**PLANNED UNIT DEVELOPMENT
& SUBDIVISION STAFF REPORT****Date: May 1, 2014****DEVELOPMENT NAME**

Tilcor Subdivision

CONTEMPLATED USEPlanned Unit Development approval to allow shared access
between two building sites, and Subdivision approval to create two legal lots from one metes and
bounds parcel.**TIME SCHEDULE
FOR DEVELOPMENT**

SITE PLAN

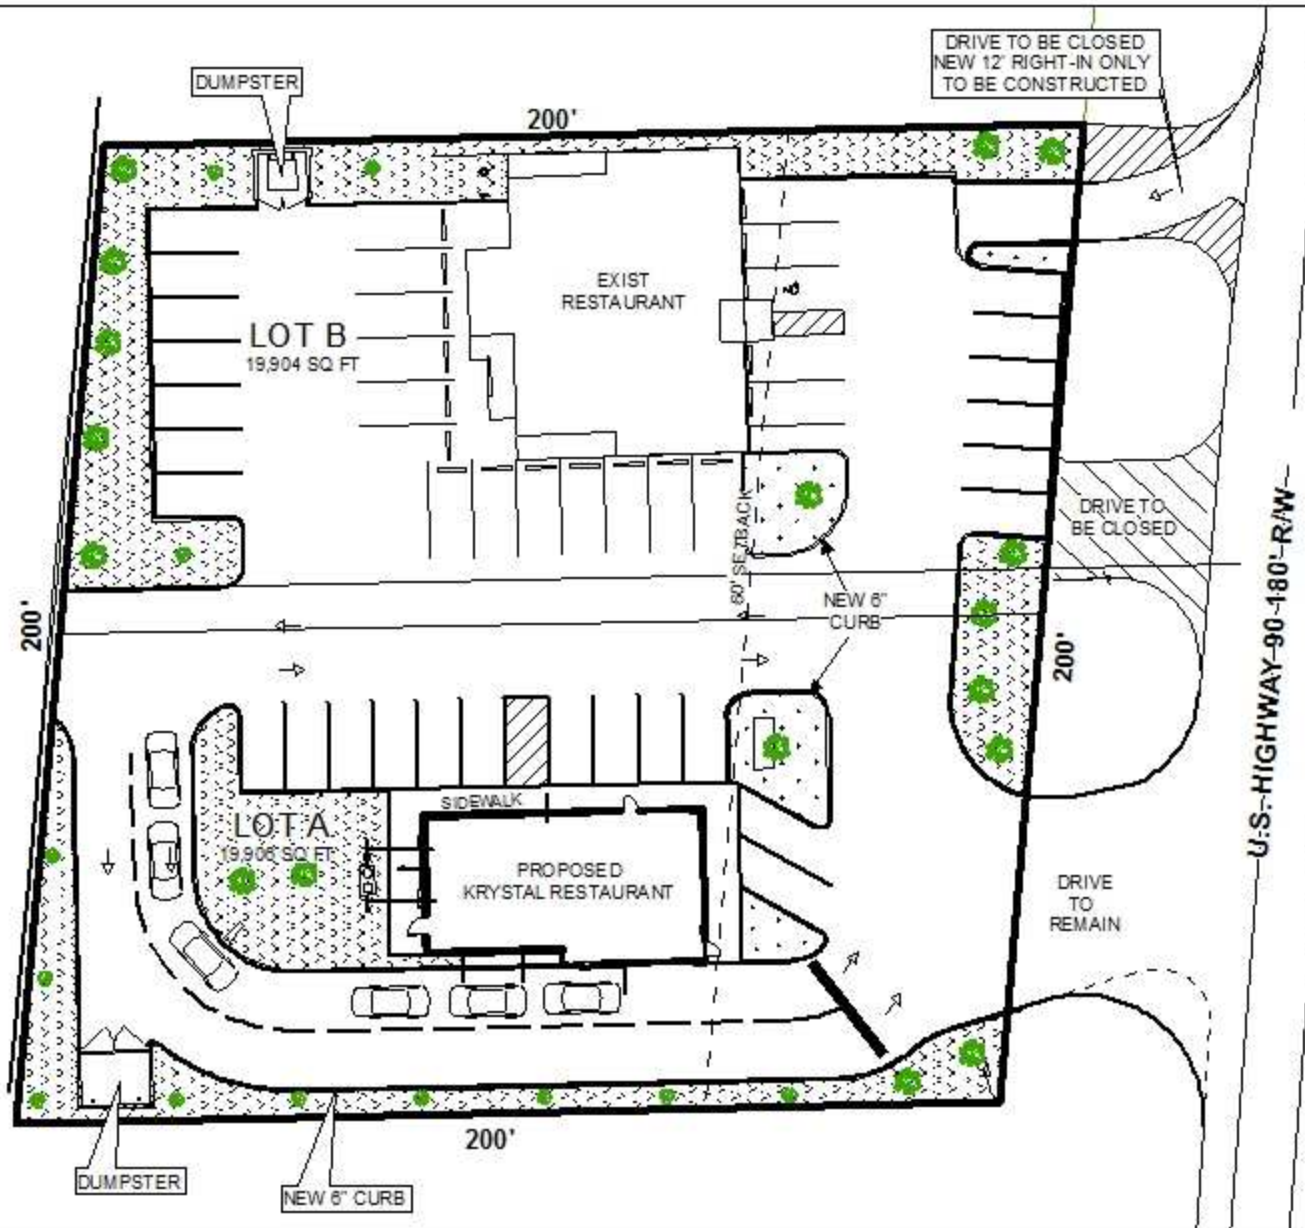
It should be noted there is a discrepancy between the revised 2-lot subdivision plat and the site plan. The site plan depicts the entire site as Lot A, but illustrates a dashed line through the lot indicating one portion of the site as 111' wide and the other portion as 89' wide. The preliminary plat depicts the site as Lot A and Lot B with both proposed lots being 100' wide each. Also, the site plan does not reflect the 60' minimum building setback line as illustrated on the preliminary plat. A revised site plan should be submitted to address the inconsistency between the preliminary plat and the site plan.

The applicant has submitted a site plan illustrating the placement of the buildings, dumpster locations, and landscaping; however, the illustration of frontage trees and perimeter trees are not depicted on the site plan. The site plan should be revised to depict the lot sizes in square feet and acres, provide the frontage and total landscaping calculations, and the total number of frontage trees and perimeter trees. A total of 29 trees, to include: 6 frontage trees, 20 perimeter trees, and 3 parking trees will be required. A revised site plan will be required prior to issuance of any permits for the site, and prior to the signing of the Final Plat.

The site plan depicts a total of 43 parking spaces for the entire site. The entire site is required to provide 38 parking spaces due to the existing and proposed restaurant uses. However, the site is proposed as 2 separate lots which would require Lot B to provide 21 parking spaces and Lot A to provide 17 parking spaces. Lot A does not have enough parking spaces to accommodate 17 vehicles, thus shared parking will be needed. A revised narrative requesting shared access as well as shared parking will be required.

It should be noted there is only one handicap space indicated and striped on the site plan, in front of the existing restaurant. The accessible parking space and access aisle is 14' wide, which is not

wide enough to accommodate a handicap accessible van. The site plan illustrates a second striped area, however, there is no designated handicap accessible space indicated on the plan.

The proposed second building is a restaurant with a drive-thru. Section 64-4.F.2 of the Zoning Ordinance addresses design standards for drive-thru business. All queuing spaces must be 9 feet wide by 20 feet long. Each drive-thru lane must provide a minimum of 3 queuing spaces between the order station and the service window, and a minimum of 3 queuing spaces from the street right-of-way to the service window. The site plan does not illustrate queuing spaces nor does it illustrate the location of a menu board and service window. A revised site plan to illustrate the locations of the menu board(s), service window(s), and queuing spaces will be required.

Two dumpsters are depicted on the site plan and do appear to be enclosed on all three sides. However, there is no indication that the dumpster will be connected to sanitary sewer. The site plan should be revised to indicate if the dumpsters will be connected to sanitary sewer. It should also be noted, when submitting for a building permit, detailed plans illustrating the dumpster within a wooden or brick enclosure of at least 6 feet, but not to exceed 8 feet, in height will be required.

The site plan depicts 43 total parking spaces in comparison to the 45 spaces that are listed in the “Parking Data” table. The “Parking Data” table should be revised to coincide with the total number of parking spaces illustrated on the site plan. Also, according to aerial photos the existing restaurant has an existing free standing sign that appears to be located in one of the

spaces which will eliminate one of the proposed parking spaces, thus the site plan should be revised to reflect this.

There appears to be an error on the site plan regarding the property line between the proposed Lot A and Lot B. The site plan depicts two separate dashed lines to indicate the centerline between the two lots. This should be revised to eliminate one of the dashed property lines, to reflect the proposed subdivision. Two revised PUD copies depicting proposed and existing features on the site will be required prior to the signing of the Final Plat.

- 1) retention of the 60' minimum building setback line;
- 2) retention of the frontage trees and perimeter trees on the site plan;
- 3) retention of the “Landscaping Data” chart depicting the total landscaping and frontage landscaping calculations;
- 4) retention of the lot sizes in square feet and acres;
- 5) placement of a note on the Final Plat stating that Lot B is limited to one right in only curb-cut and Lot A is limited to one curb-cut onto U.S Highway 90 West, with the size, design, and location to be approved by Traffic Engineering and ALDOT, and conform to AASHTO standards;
- 6) retention of the dumpsters on the site plan;
- 7) retention of the note on the site plan stating dumpsters will be enclosed on all three sides and connected to sanitary sewer;

- 8) retention of the 24' wide drive aisles as depicted on the site plan;
- 9) submission of a sidewalk waiver prior to the approval of any permits;
- 10) labeling of the right-of-way width of U.S Highway 90 West on the site plan;

- 11) revise site plan to remove one of the dashed lines to indicate the center property line between Lot A and Lot B matching the proposed subdivision;

- 12) revise site plan to show all existing and proposed features, including the freestanding sign in the parking space;
- 13) revise the "Parking Data" table to coincide with the number of parking spaces depicted on the site plan;

- 14) modify existing and proposed parking spaces to provide one 9-foot wide van accessible parking space with a 7- foot wide access aisle, and appropriate signage;
